MAG Standard Specifications and Details Committee
TENTATIVE AGENDA
April 6, 2016

MEETING MINUTES FROM THE
MARICOPA ASSOCIATION OF GOVERNMENTS
STANDARD SPECIFICATIONS AND DETAILS COMMITTEE

2016 PROPOSED REVISIONS TO MAG SPECIFICATIONS AND DETAILS

DATE: April 6, 2016
TO: MAG Specifications and Details Committee Members
FROM: Warren White, City of Chandler Representative
SUBJECT: Proposed Revisions to Detail 270 and Section 616 (UPDATE)

SQUARE FRAME AND COVER
AND GRADE ADJUSTMENT

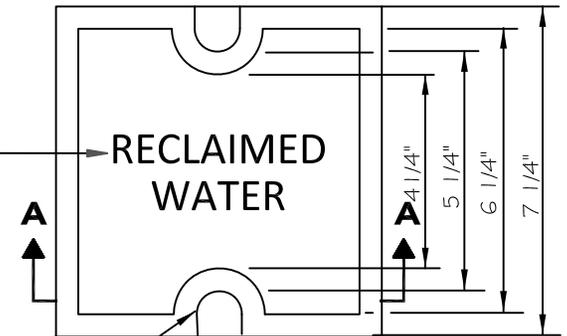
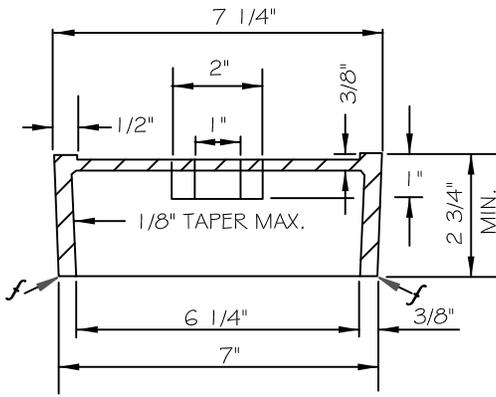
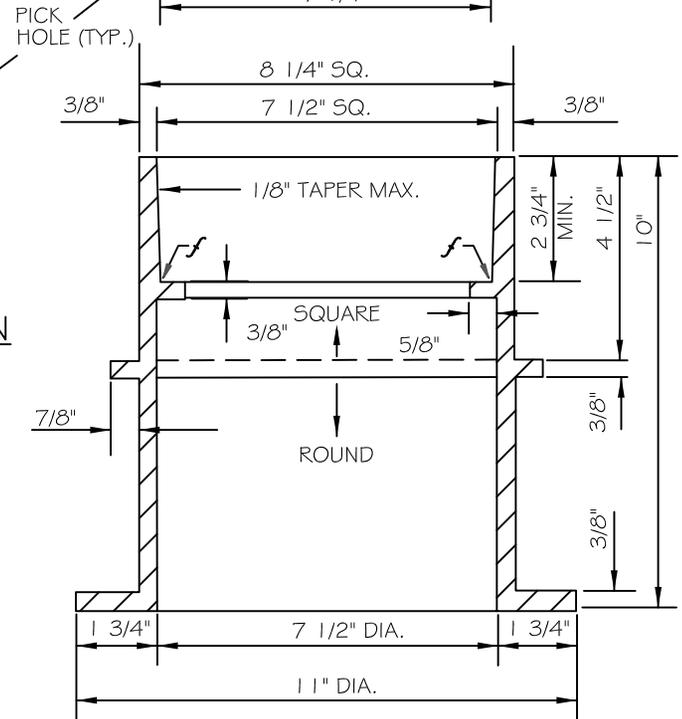
Warren White provided a revised Detail 270-2 that included minor updates discussed at the previous meeting. This included removing the word “VALVE” from the plan and the notes. He also proposed removing the text “TYPE OF LETTERS TO BE SUBMITTED FOR APPROVAL” from note 2. Bob Herz suggested changing the detail number to 271 since Detail 270 is referenced on four other details. He thinks it would be easier to change this detail number rather than update the other four details. Section 616 would then need to be updated to reference Detail 271.

- New “SQUARE FRAME AND COVER AND GRADE ADJUSTMENT” Detail 271 (instead of previously proposed Detail 270-2).
- Revise current Detail 270 and proposed Detail 271, removing text “TYPE OF LETTERS TO BE SUBMITTED FOR APPROVAL” from note 2.
- Revise Section 616 Reclaimed Water Line Construction as follows:

1. CASTING TO CONFORM TO SECT. 787.
2. LETTERS ON COVER TO BE AS FOLLOWS, PER AGENCY REQUIREMENTS:
3/4" HIGH "RECLAIMED WATER" OR 1/2" HIGH "NONPOTABLE WATER".
LETTERS TO BE RAISED 1/16".
3. *f* INDICATES MACHINE FINISHED SURFACE.
4. VALVE BOX SHALL HAVE A ROUND BOTTOM TO ACCOMMODATE RISER PIPE.

**DUAL CURB RAMPS (RADIAL)
ATTACHED SIDEWALK**

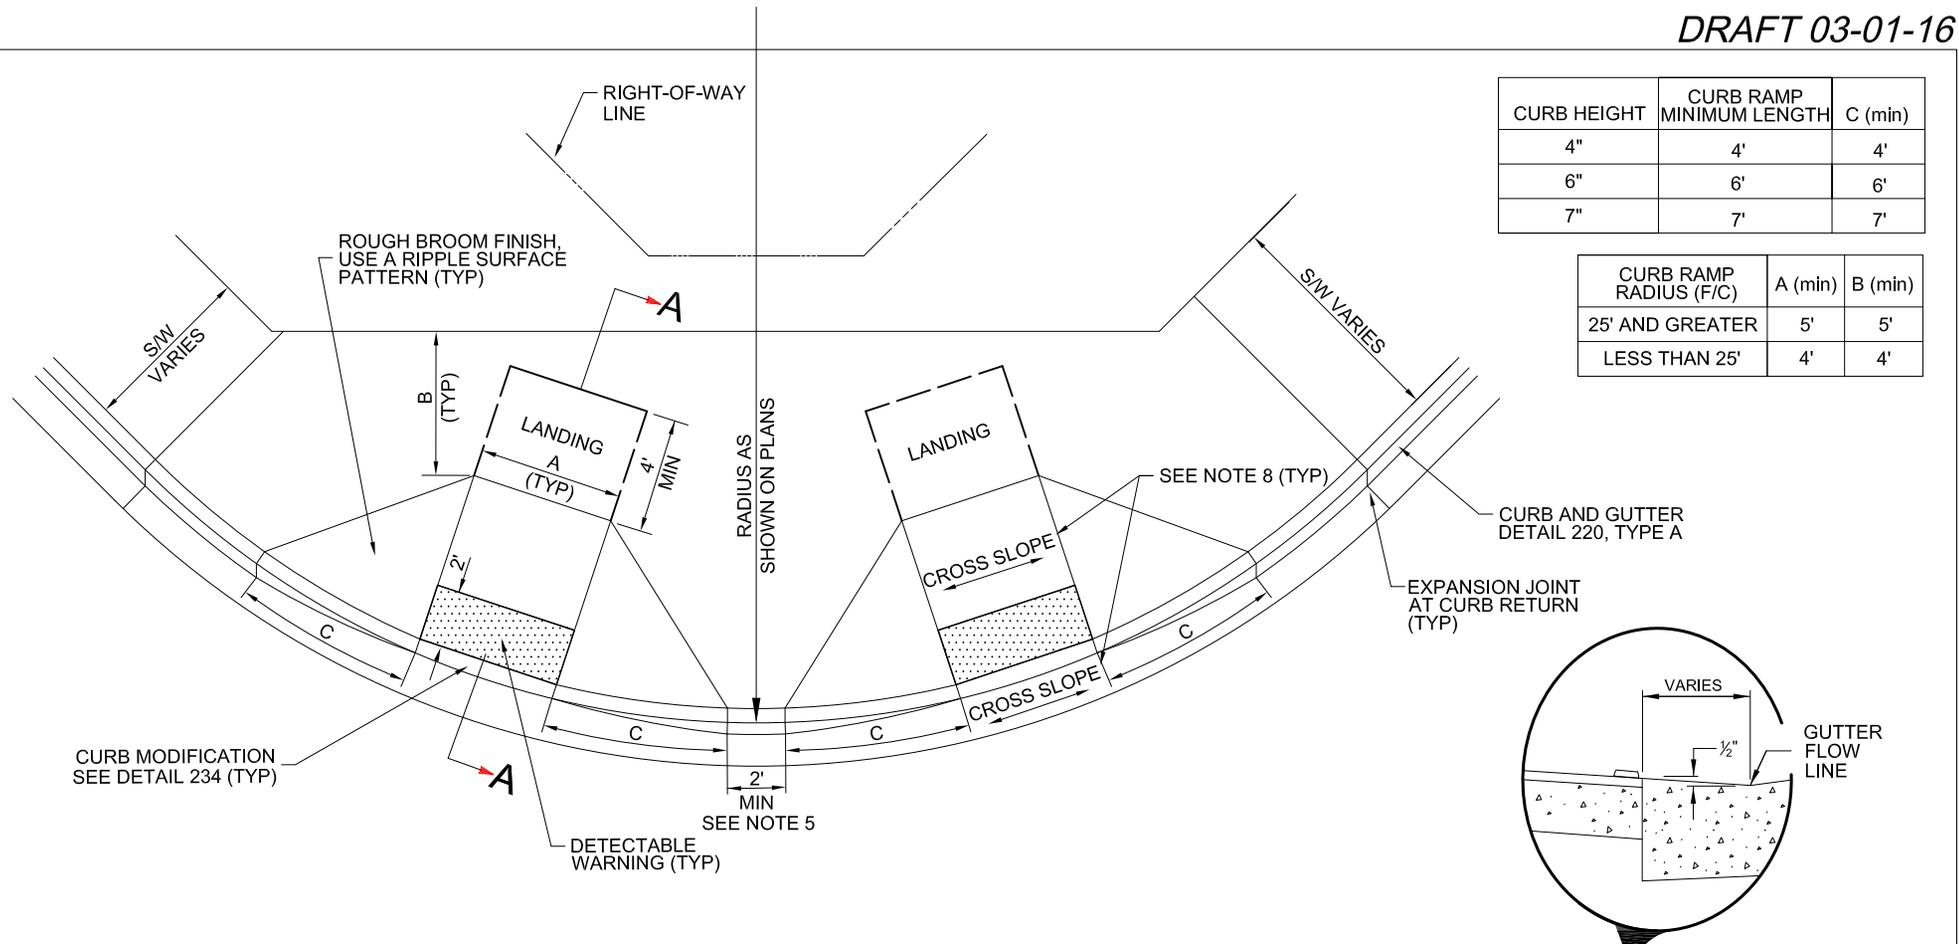
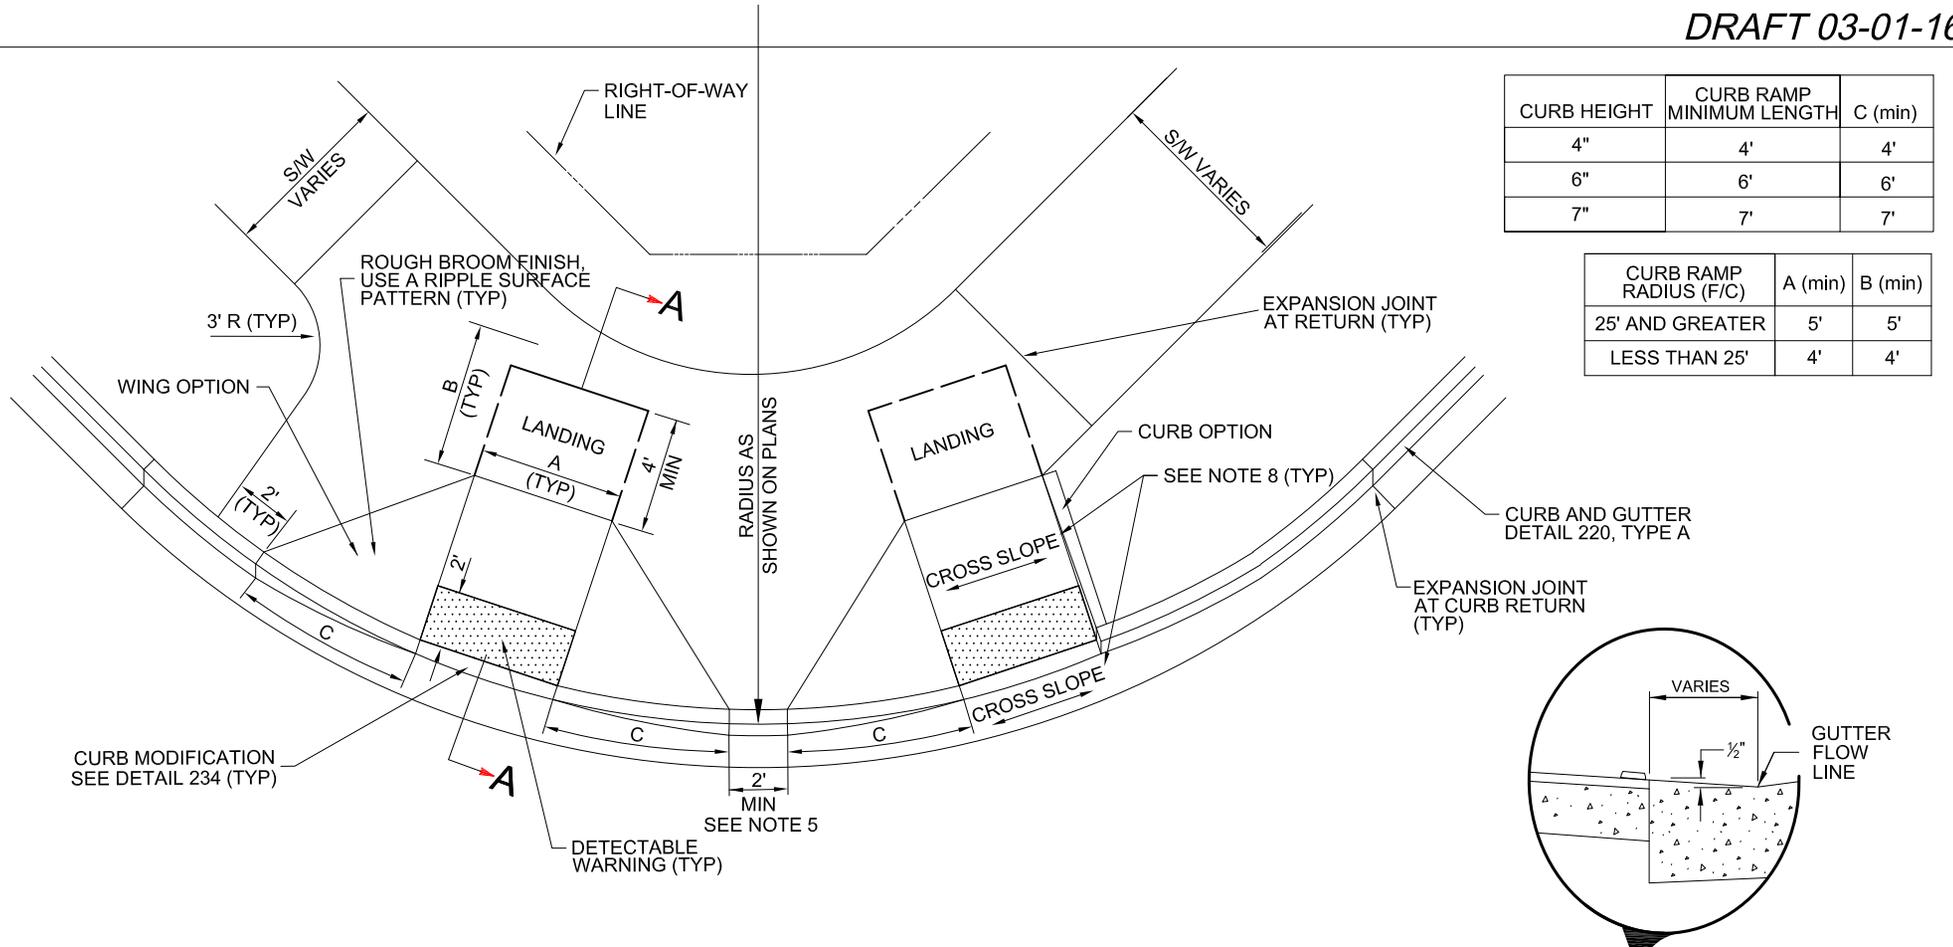
Warren White asked for comments on the radial ramp detail. Bob Herz had several comments and revisions that he brought up. One issue was that you need a 5' top landing area aligned in the ramp direction clear of vertical obstructions such as a curb or pole, this can affect right-of-way. He also mentioned that objects such as valve boxes should not be located in the ramps. Mr. Herz thought the distances for B in the table should be the minimum accessible route width. He shared all his suggested revisions, and Mr. White made notes on the drawings to update them. Issues discussed included:

- Editing note 8 to change "turning space" into "landing" to be consistent with the detail labelling and also deleting all that followed 'cross slope'.

- Making changes in the written specs – Section 340.3.9
- Showing the detail in the plan view rather than a slightly isometric view.

- New Detail 236-1 “DUAL CURB RAMPS (RADIAL) ATTACHED SIDEWALK”
- New Detail 236-2 “DUAL CURB RAMPS (RADIAL) DETACHED SIDEWALK”
- New Detail 237-1 “DUAL CURB RAMPS (DIRECTIONAL) ATTACHED SIDEWALK”
- New Detail 237-2 “DUAL CURB RAMPS (DIRECTIONAL) DETACHED SIDEWALK”
- Revise Section 340 “CONCRETE CURB, GUTTER, SIDEWALK, CURB RAMPS, DRIVEWAY AND ALLEY ENTRANCE” as follows, adding sentence to end:

DETAIL NO.
237-1

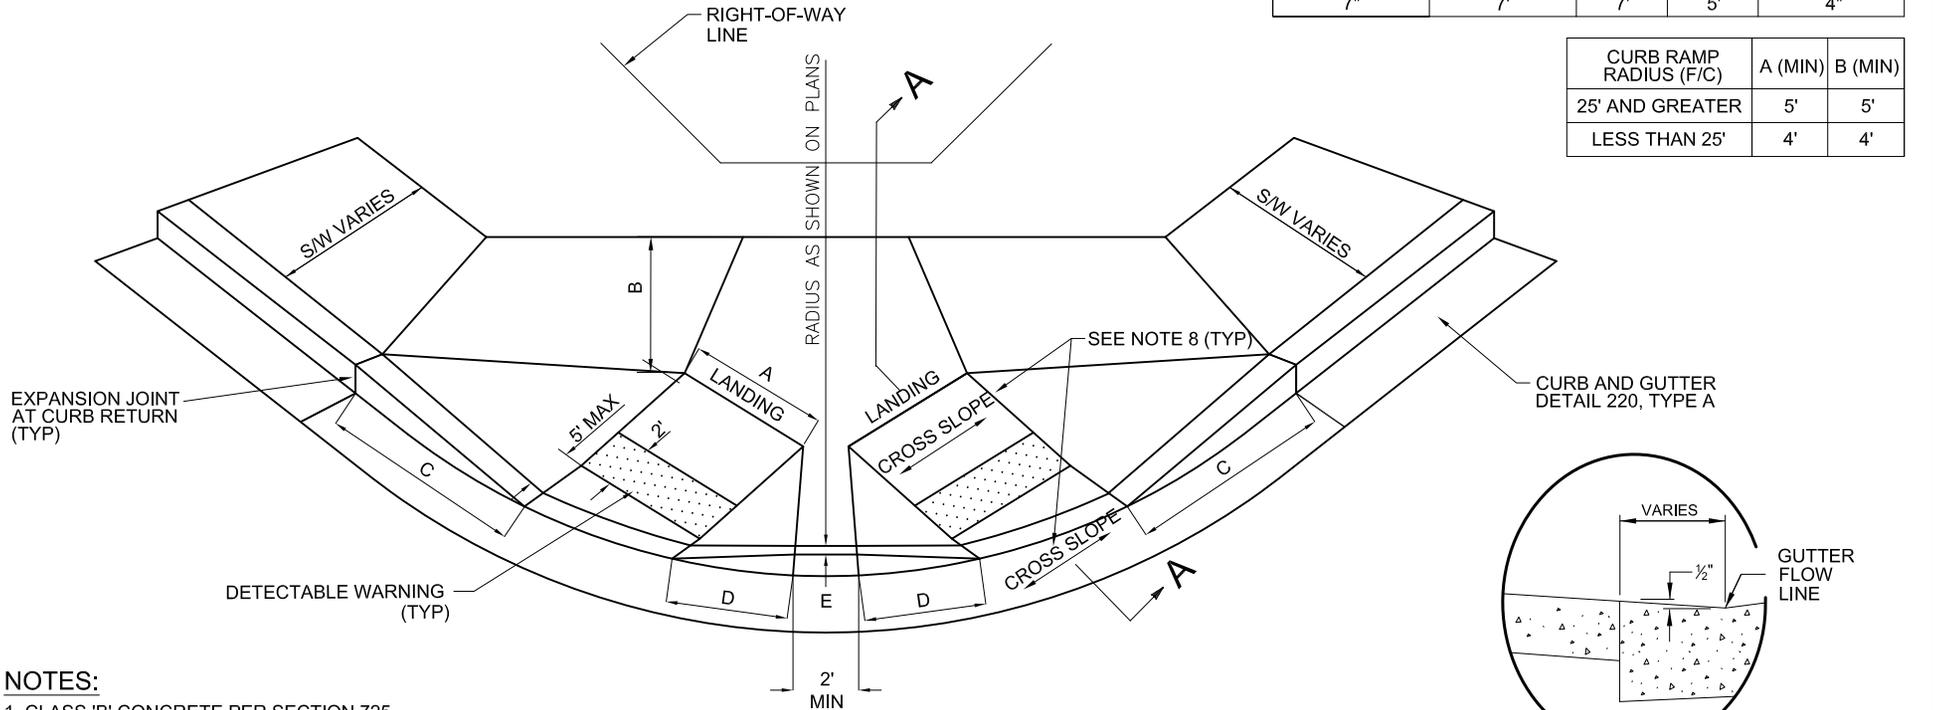
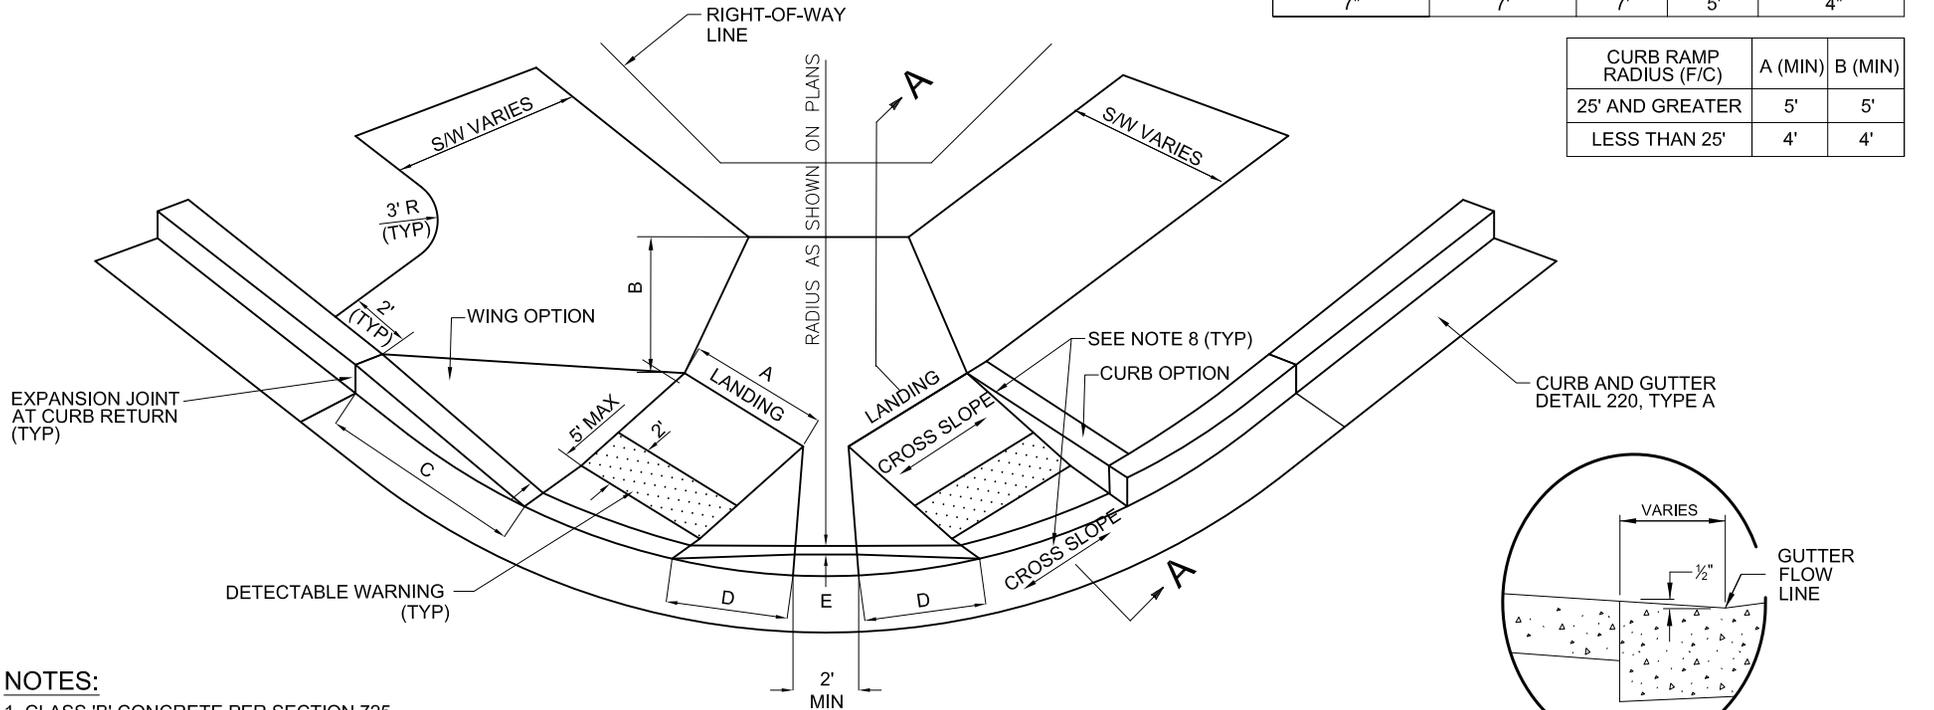
- Constructing the ramps, traditionally and with a monolithic pour. Mr. Forrey said Peoria will be building a ramp based on this detail as a test.
- Showing the joints between ramps.

- Clarifying dimension E on the plan view.
- How adjusting the minimum distance between ramps down to 1' could affect the design, and also how moving them farther apart to align with crosswalks affects the wing size.

- Revising the section view to remove the cross slope note at the bottom landing area as well as the counter slope note, and fixing the blow-up view.
- Requiring spot elevations at the bottom corners of the detectable warnings and gutter elevations at the center and ends of the curb returns to make sure there is proper drainage.

Warren White and Brandon Forrey plan to review and update the details based on feedback provided during the meeting.
